CREEKWOOD SUBDIVISION, UNIT III

APPLICATION NUMBER Holdover DATE April 5, 2007

DETAIL SITE PLAN

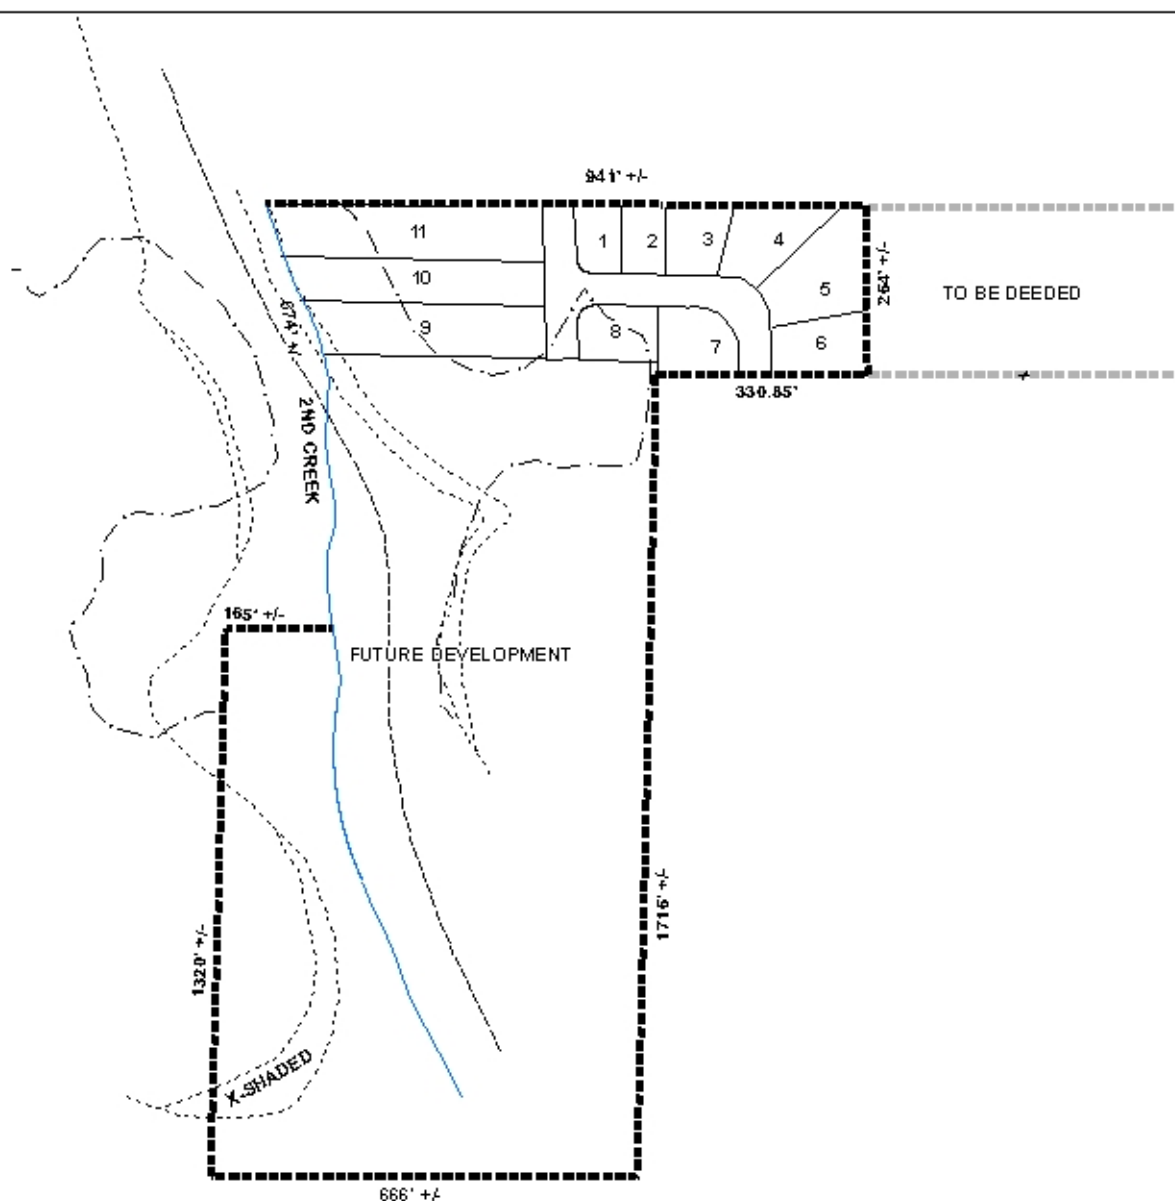
All proposed lots appear to meet minimum dimensional requirements, however, lots 18 through 24 appear to have up to just over half the lot encumbered by the floodplain for a branch of Second Creek. Several lots also appear to be impacted by the floodway associated with Second Creek.

Both proposed “future development” areas appear to be encumbered by floodplains, and the presence of branches of Second Creek as well as the topography appear to limit the applicant’s options regarding future development. It should be pointed out that the eastern “future development” area appears to be landlocked, thus the plat should be revised to at minimum show a dedicated access to each “future development” area from the public right-of-way so that maintenance vehicles can access the areas. Due to the environmental constraints, it would appear more likely that the “future development” areas will become unmaintained common areas.

A revised plat was received showing access to one adjacent land-locked parcel, but no longer showing the “future development” area to the East, thus not including the remainder of a lot/parcel and leaving it in a “land-locked” condition. The plat was not revised to include the remainder of the parcel to the West, as requested, nor was any information provided regarding the prior division of land without the subdivision process. Furthermore, additional research by staff shows that a portion of the site under consideration is part of an approved subdivision that has not yet been recorded (Pine Valley, Second Addition), and that will not expire until June 2007.

The application was heldover from the March 1st meeting at the applicant’s request. A revised plat was provided showing only 11 lots, leaving a large area reserved for “future development,” and deeding a portion of land (approximately 6 acres) to an adjacent property owner. The proposed deeding of property to an adjacent property owner necessitates the inclusion of the property owner into the subdivision process in order to create a legal lot with frontage on a public street: this has not occurred. Furthermore, the revised plat still does not take into

account the full extent of Lot 1 of Wellsville Farms, which appears to have been sold without going through the Subdivision process.

Based upon the preceding, the application is recommended for Denial for the following reasons:

- 1) the sale of the remainder of parcel R023303062000001. (West side of Second Creek, specifically the portion of Lot 1 of Wellsville Farms) occurred without the appropriate subdivision process;*
- 2) the remainder of parcel R023303061000002. will be land-locked;*
- 3) there is no provision of access to most of the adjacent land-locked parcels; and*
- 4) the proposed subdivision is utilizing land currently part of an existing approved but unrecorded subdivision.*
